REQUEST: **Certificate of Appropriateness for Major Alteration**
 • **Modification to Previously Approved Certificate of Appropriateness for New Construction of a Two-Story Duplex (HPB Case No. H18030) to Change Styles of Windows, Doors, and Garage Doors on the Front Façade; Revision of the Stucco Scoring Detail on the Front Façade; and Change of Driveway Paving Material.**

Case Number	PLN-HP-20010002	FMSF#	BD2797
Owner	SB 1010, LLC		
Applicant	SB 1010, LLC		
Address	1010 SW 2nd Court		
General Location	Approximately 160'-0" feet west of the SW 10th Avenue and SW 2nd Street intersection on the south side of street.		
Legal Description	WAVERLY PLACE 2-19 D LOT 26,27 & N1/2 OF VAC ALLEY ABUTTING SAID LOTS BLK 112		
Existing Use	Residential (Duplex)		
Proposed Use	Residential (Duplex)		
Zoning	RML-25		
Applicable ULDR Sections	47-24.11.D.3.c.i, 47-17.7.B		
Authored By	Trisha Logan, Urban Planner III

1010 SW 2nd Ct - Front Elevation

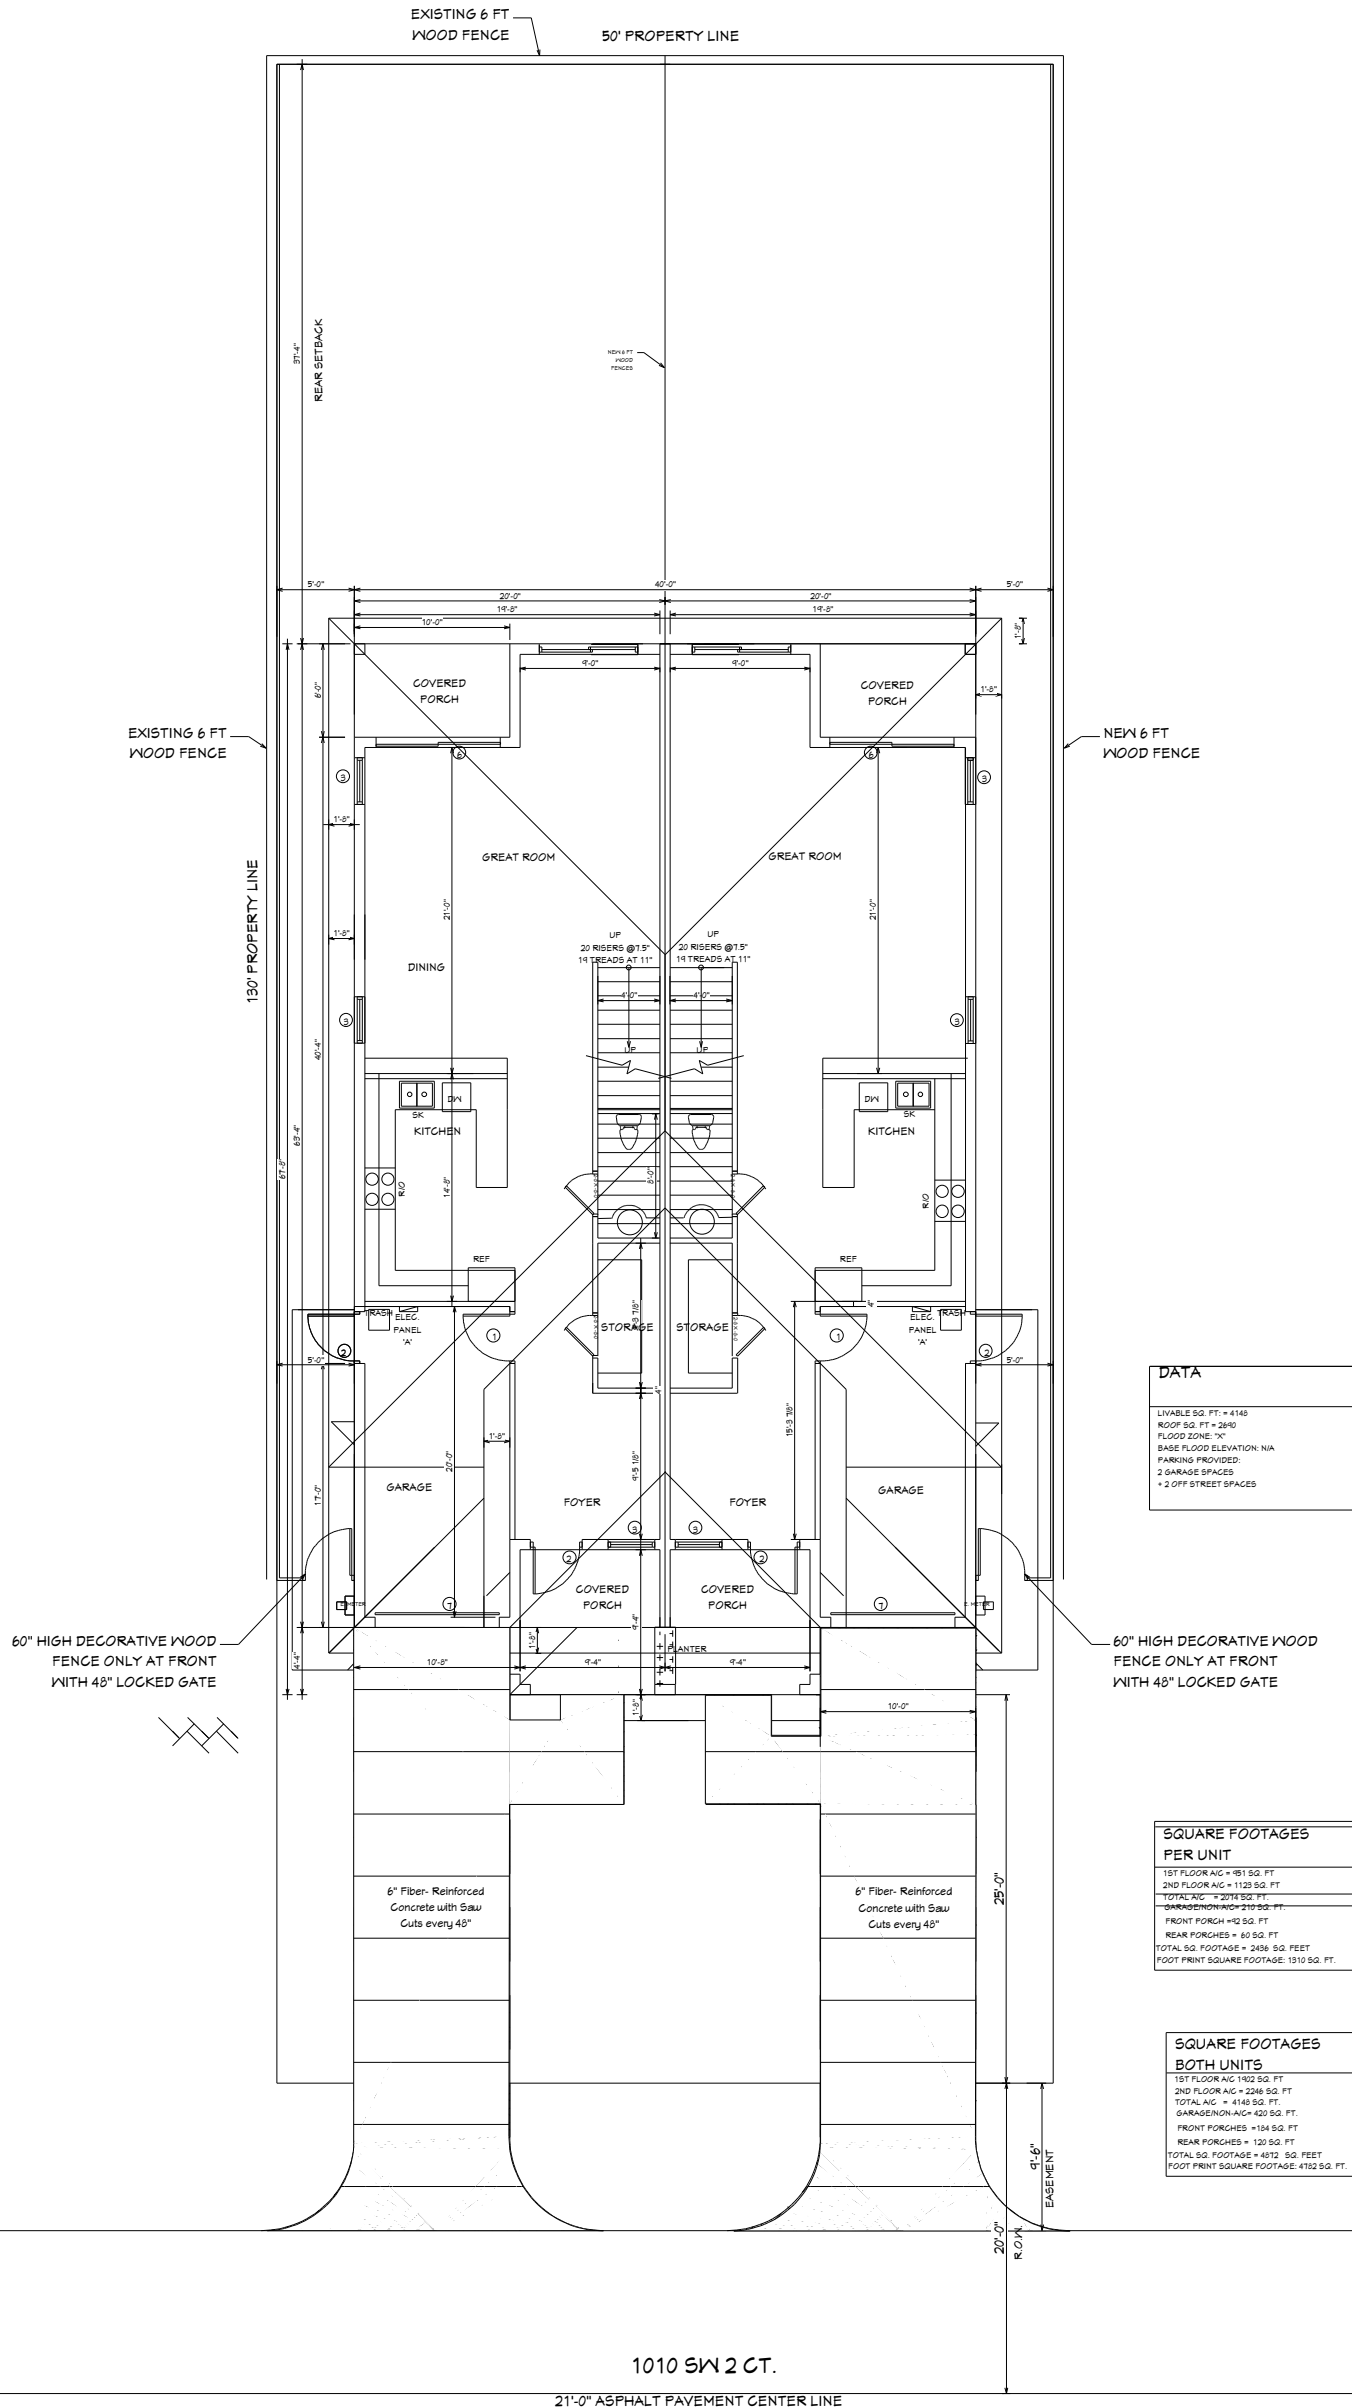
ABOVE – 1121 SW 2nd CT with Single Hung Windows reflecting equal metal to glass ratio

BELOW – 1010 SW 2nd CT with Horizontal Slider Windows reflecting same metal to glass ratio with pre-untin installation;
